STAFF REPORT

FILE NUMBERS: 247-15-000170-CU / 171-SP / 172-LM

PROPOSAL: The applicant requests approval of a conditional use permit and site plan review to allow the development of a solar voltaic array (solar farm) on property zoned Exclusive Farm Use-Tumalo/Redmond/Bend (EFU-TRB) subzone. Landscape Management (LM) Site Plan Review is also proposed as the development would be visible from Highway 20, the LM feature.

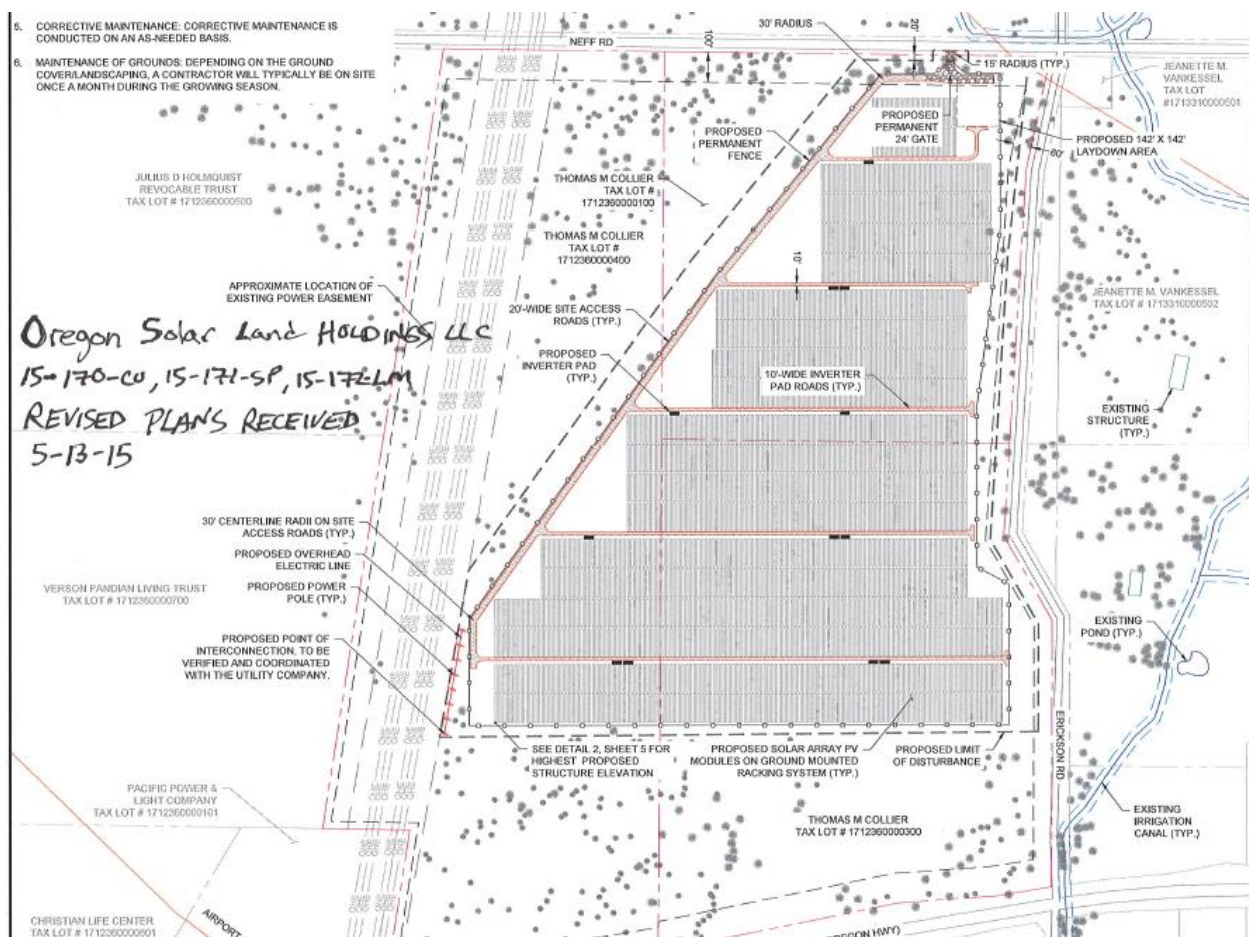
Observing setbacks from these property lines would require a revision to the submitted plans and possibly submittal of a land use permit for a modification of application. Alternatively, the applicant could place the applications on hold to process a lot consolidation unless it could be imposed as a condition of approval.

If the legal lots of record were to be consolidated, the proposal would with (B) and (C) above, as the proposed solar panels are shown on the revised plans to be set back at least 450 feet or farther from the from the western (rear and side) property lines and comply with solar setback requirements. Staff is unaware of any other setbacks imposed by building or structural codes adopted by the State of Oregon or the County, but those requirements would be reviewed by the County Building Division upon submittal of required permits. An excerpt of the revised site plan (Sheet 3 of the May 13, 2015 submittal) is depicted below:

Until the lots are consolidated or the submitted plans modified to comply with the 25 foot side and rear yard setbacks and solar requirements, Staff finds that the current proposal does not comply with the yard requirements of this section.

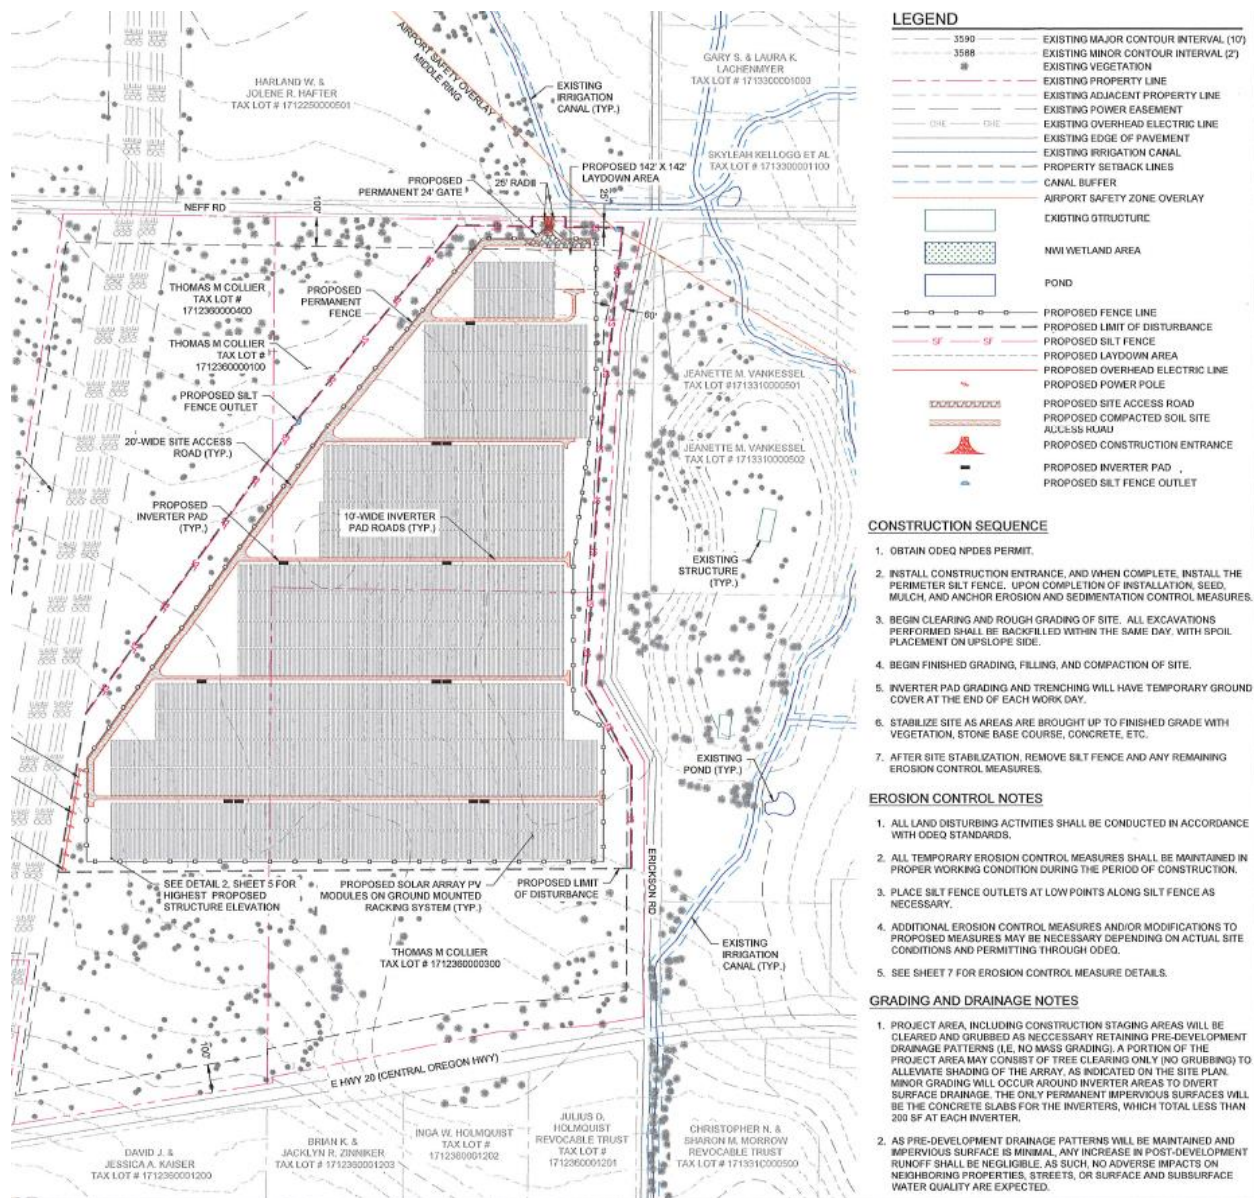
Applicant Response: The revised site plan does identify proposed vehicular circulation roads and maneuvering areas. The proposed drive aisles will provide easy access to the maintenance technician during quarterly inspections. As no public access to the site or interaction/connectivity with adjacent property is planned, no road connections need to be made. The appearance of the roads will be screened from view via native vegetation, the perimeter ring of trees proposed and the tan-colored mesh over the perimeter fence.

Access aisles will be compacted prior to construction to reduce rutting. Gravel will be used in high traffic or poorly drained areas during construction. Soil access aisles will be scarified, aerated and re-seeded after construction. Only one entryway is proposed.

With infrequent usage of the internal roads, during occasional maintenance, one point of access to the facility on the north side of the property off of Neff Road, coupled with screened fencing, a hedge, and perimeter trees, staff believes this criterion is met.

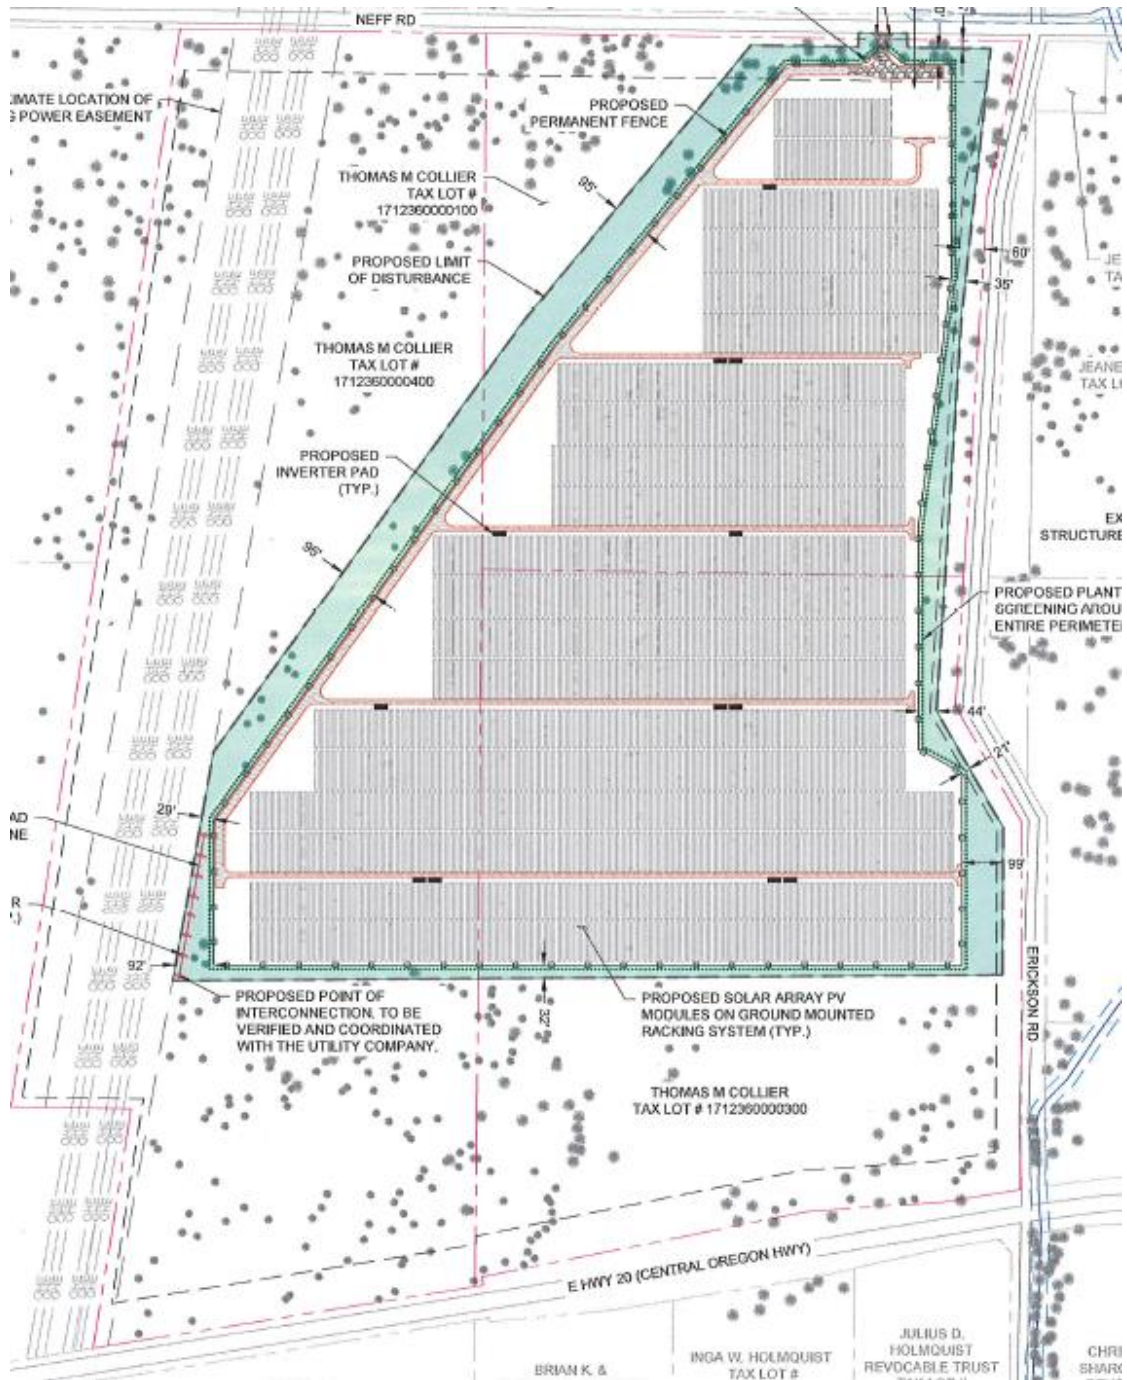
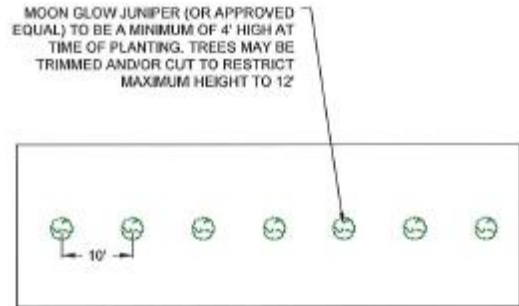
FINDING: In the incomplete application letter, dated April 22, 2015, staff provided the following comment:

STAFF COMMENT: The submitted burden of proof statement, and Landscape Plan, suggests introduction of evergreen trees between Highway 20 and the proposed development, but the submitted Landscape Plan does not identify the location of these trees. Please provide location of the proposed trees on the Landscape Plan.

PLANTED SCREENING DETAIL
NOT TO SCALE

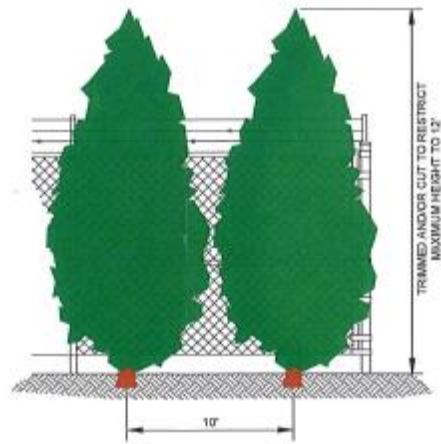
The applicant indicates that the Moonglow Juniper shrubs would be a minimum of four (4) feet at the time of planting, however, staff suggests this height be increased to a minimum of six (6) feet to help mitigate visual impacts more immediately. Staff suggests that if approved, the following condition of approval be imposed:

- a) Install the 6 foot cyclone fence with tan colored mesh screening.
- b) Plant the shrubs in the locations shown on the approved Landscape Plan. The shrubs shall be a minimum of 6 feet at the time of planting.
- c) Mesh screening shall be installed along the perimeter fence.
